CITY PLAN COMMISSION STAFF REPORT

Project Name
Plaza East Apartments

Request
CD-CPC-2022-00192
Development Plan - Residential

OVERALL SITE PLAN

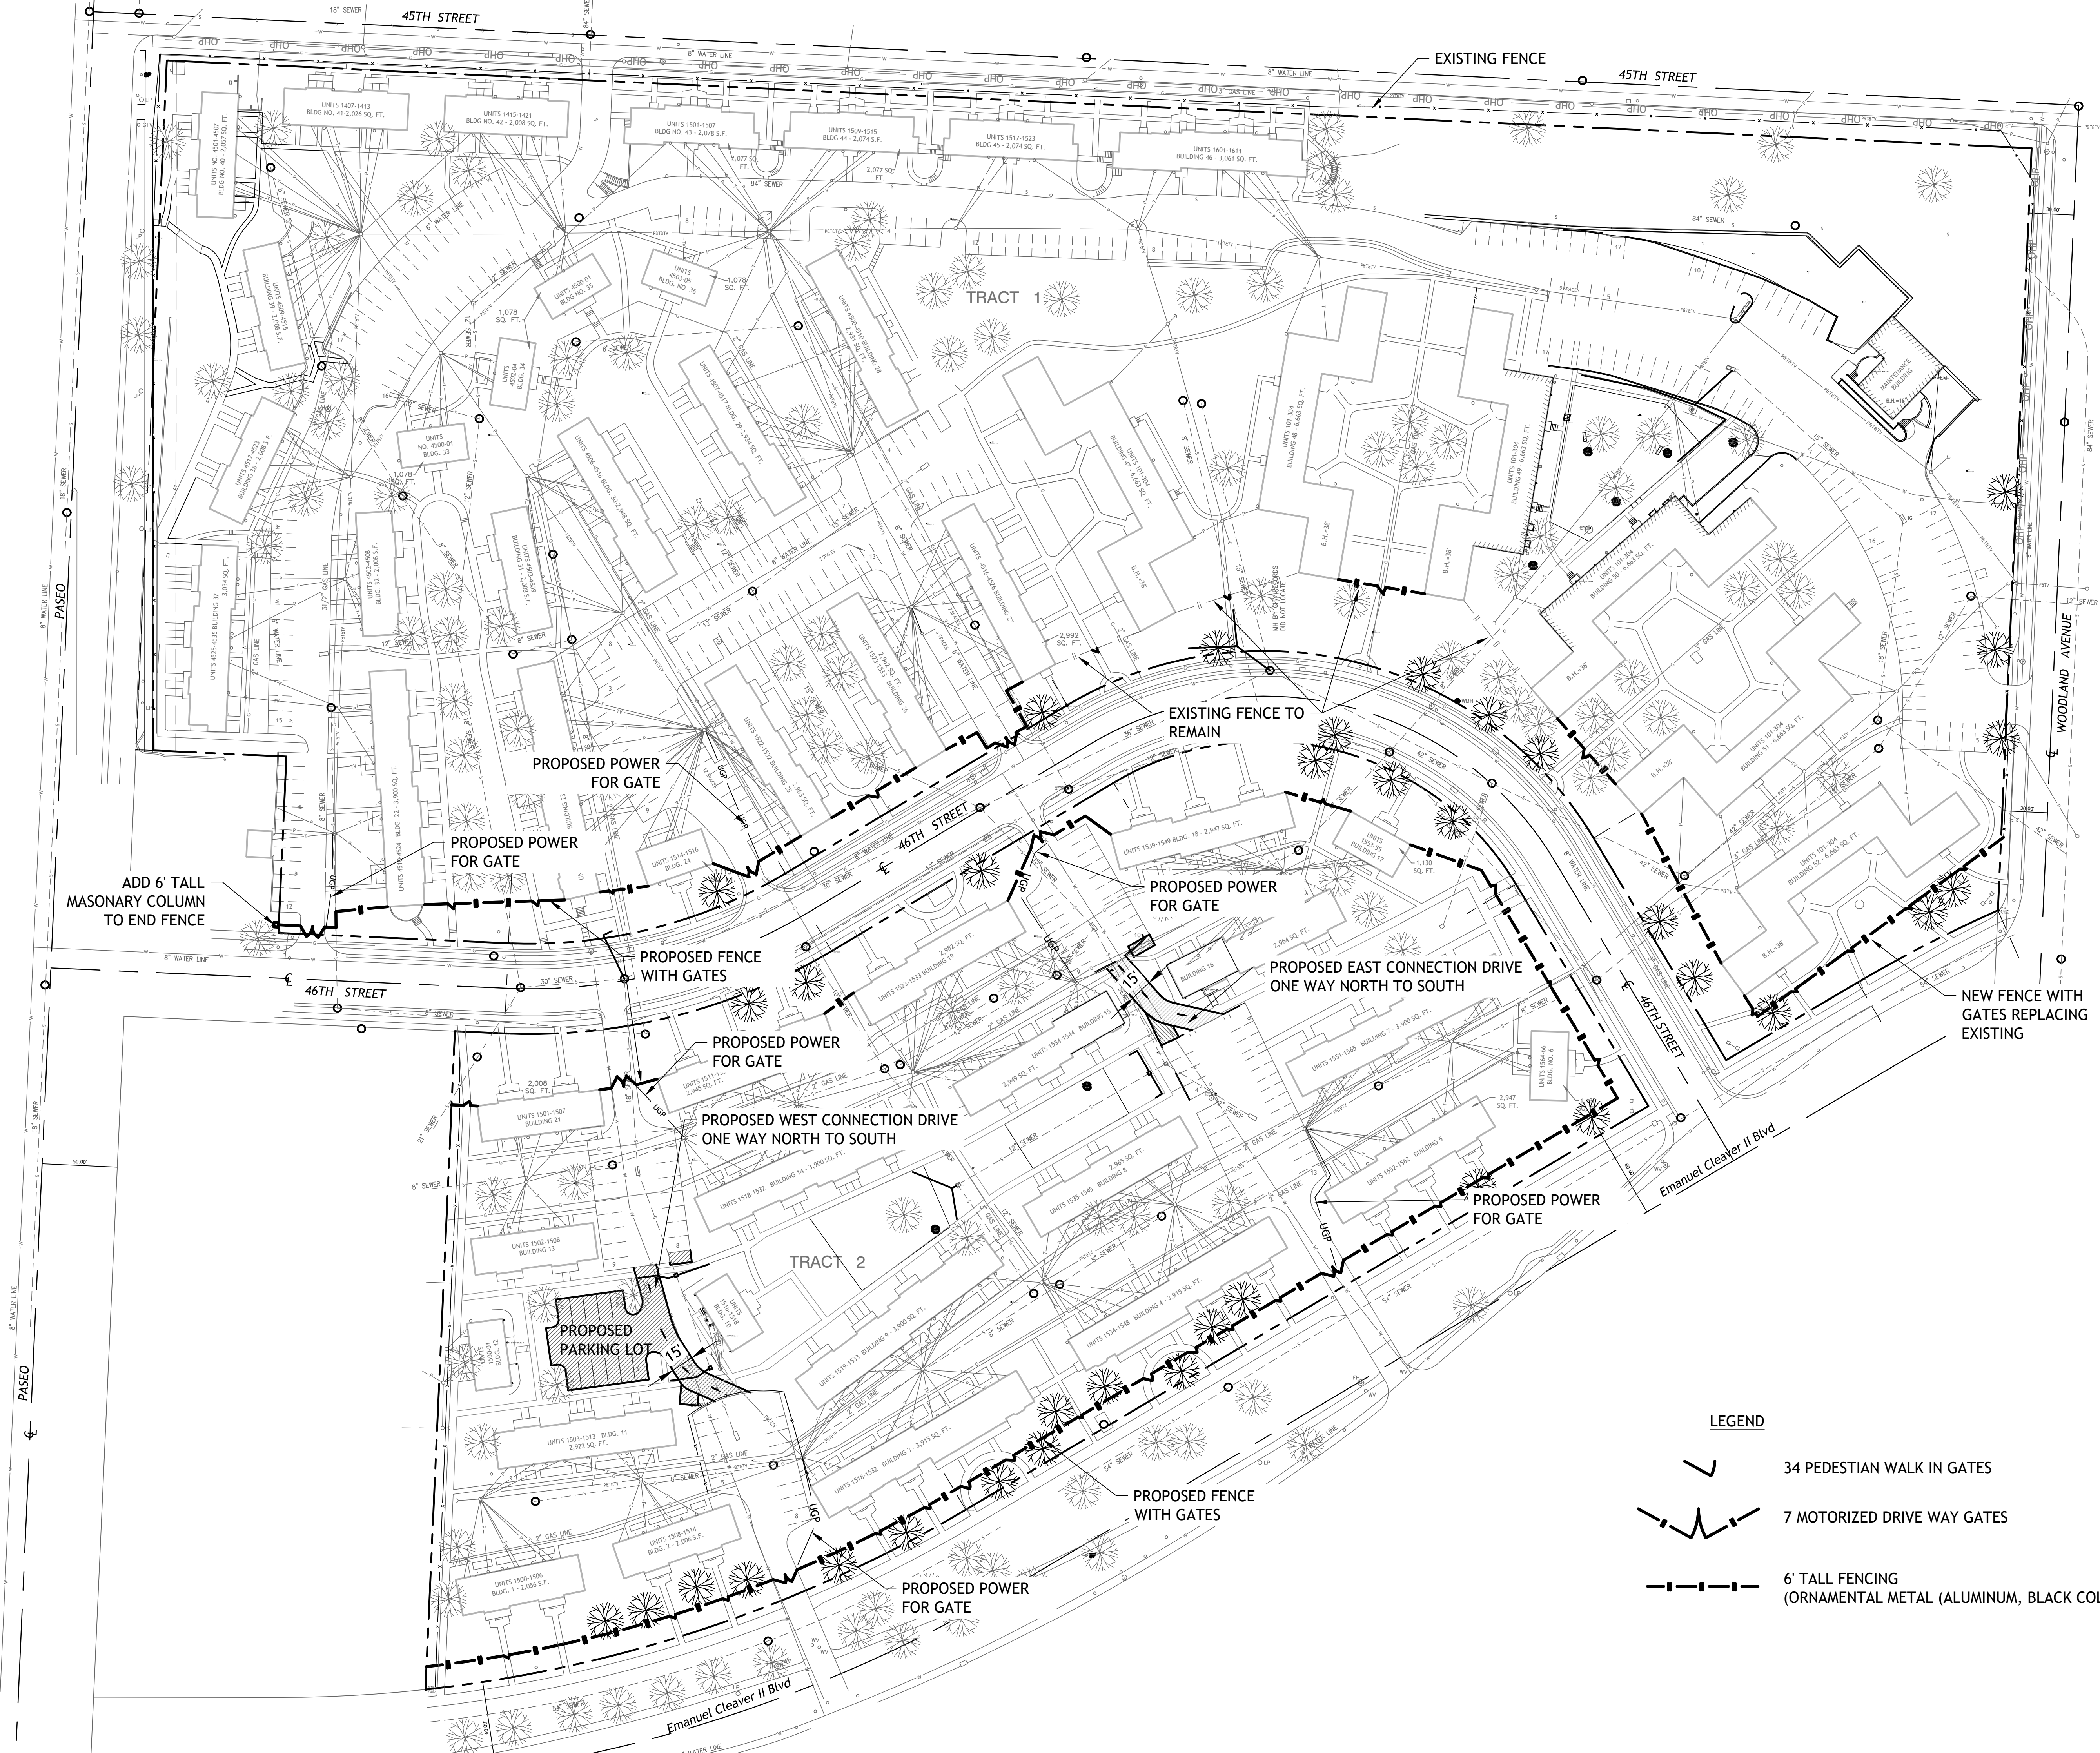
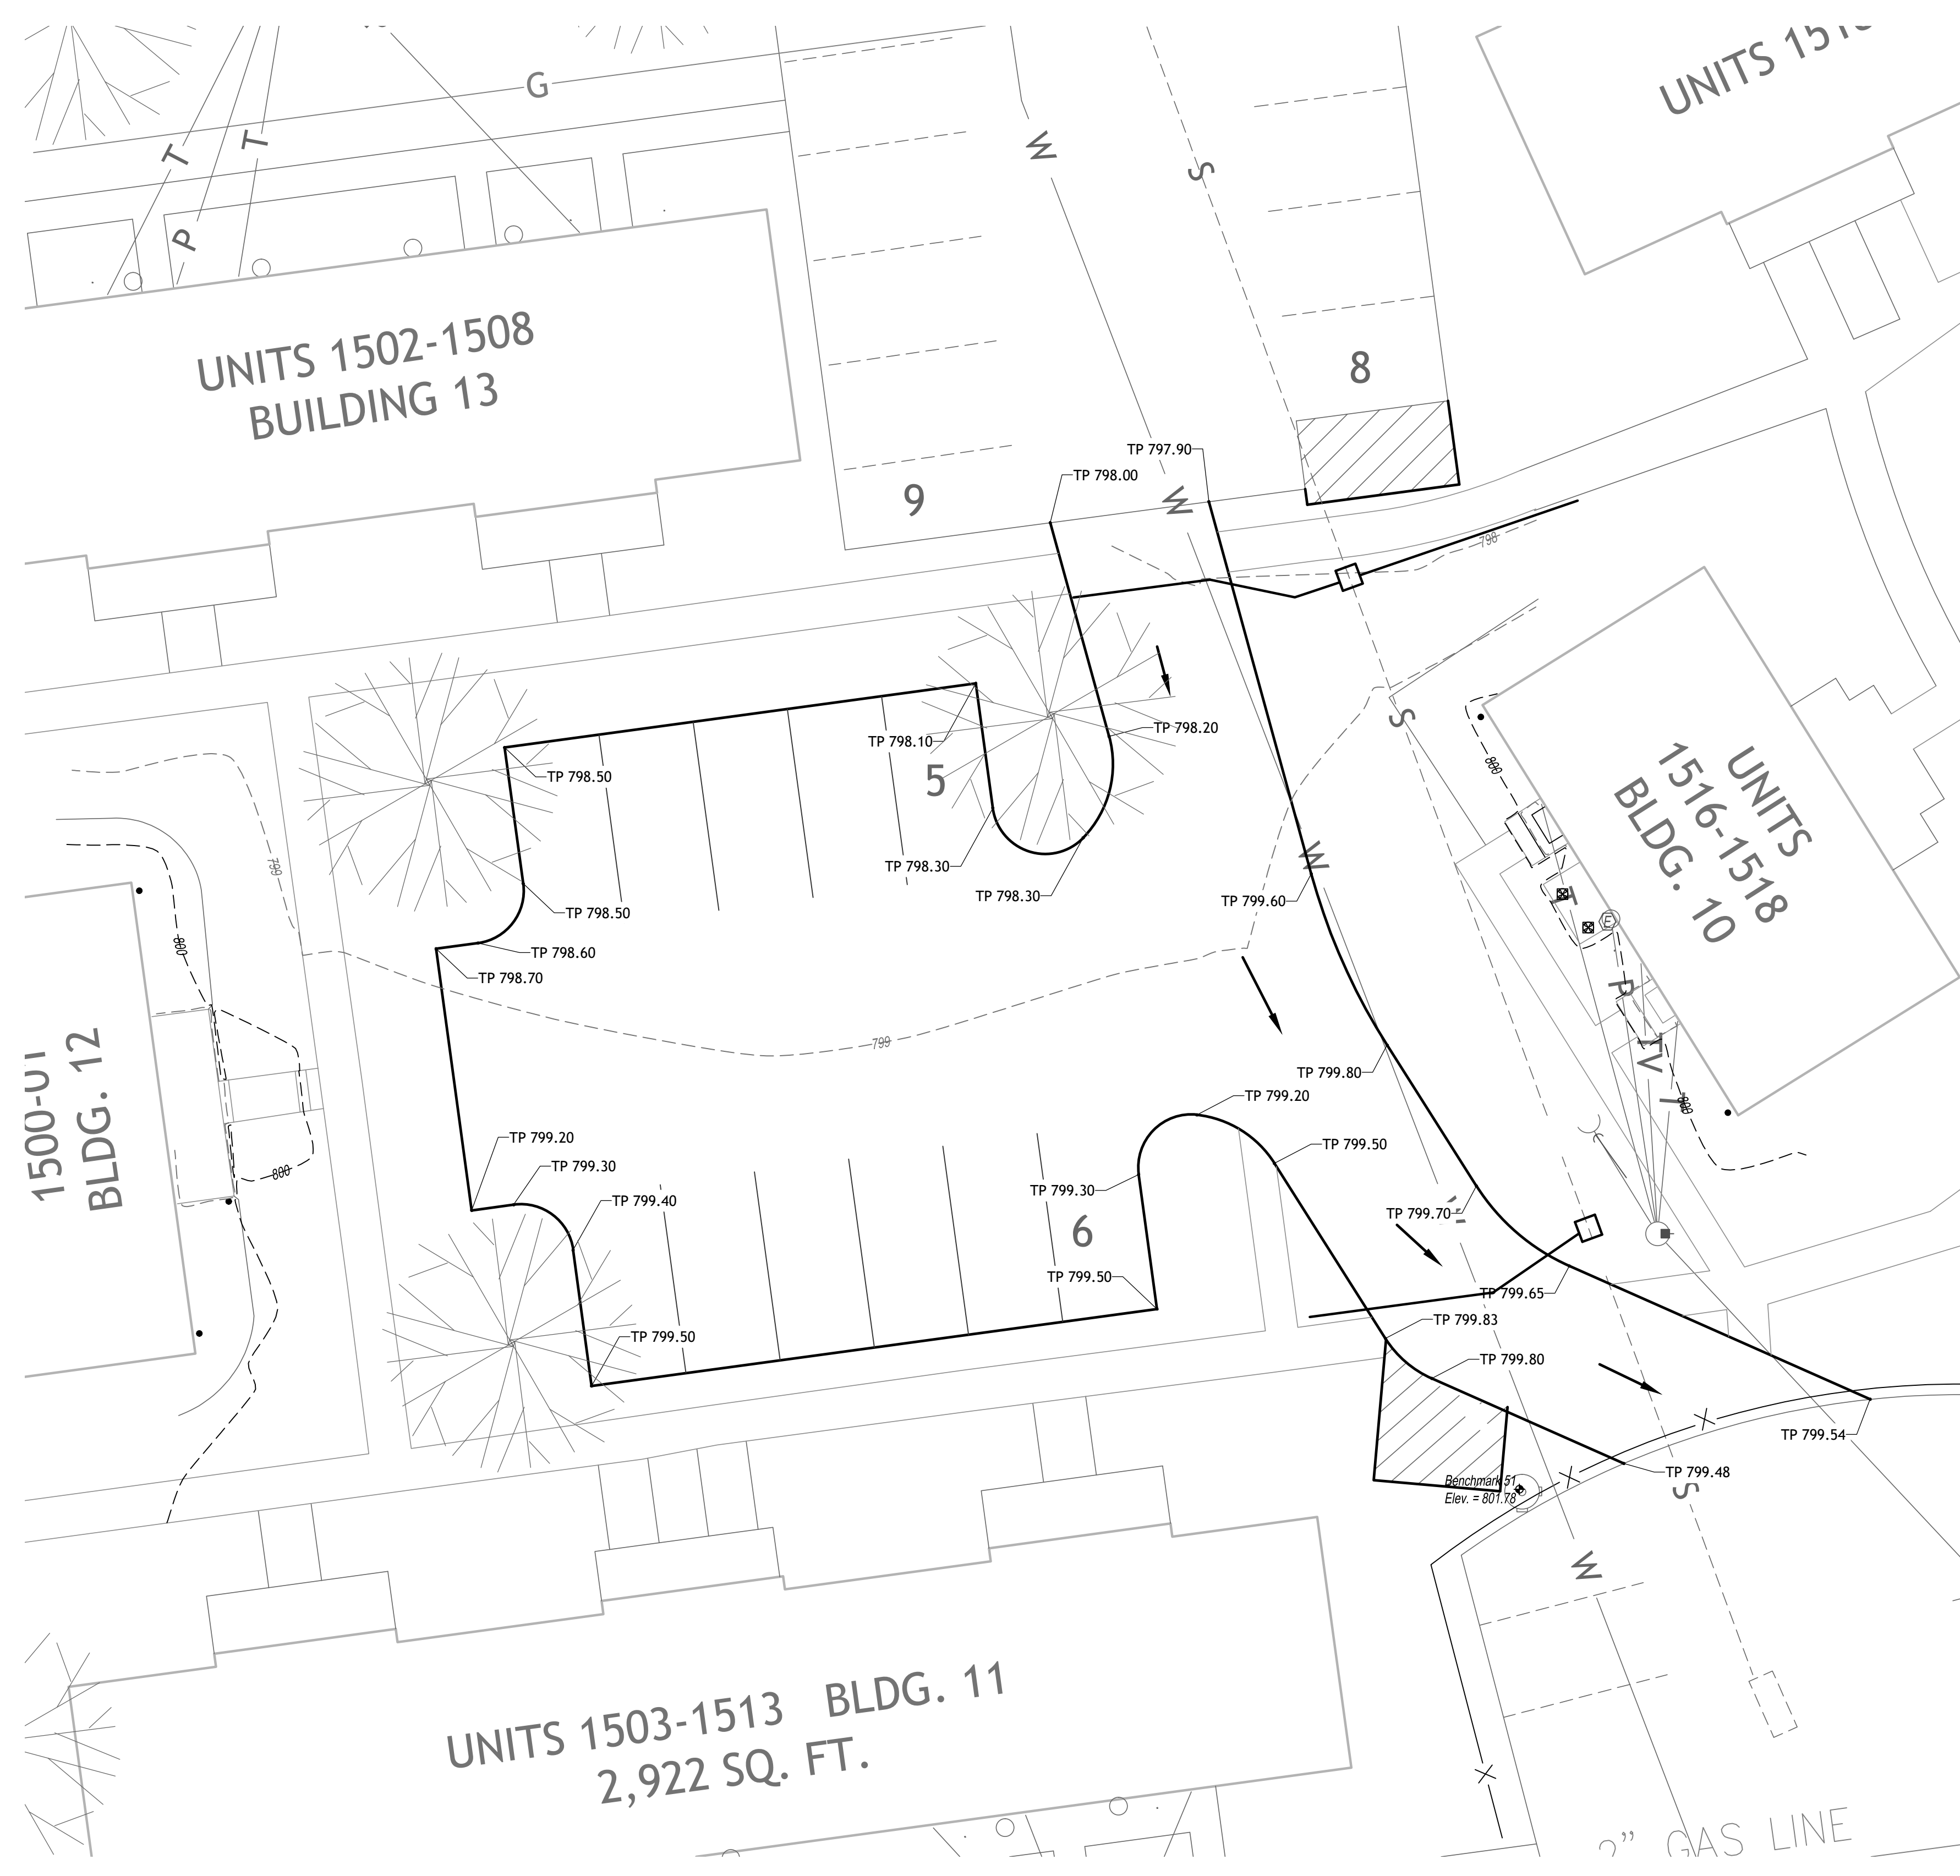
6. Security gates which span across a fire access road shall provide a means for emergency operation. Electric gates shall require a siren sensor device typically referred to as a "yelp gate" (IFC-2018 § 503.6).
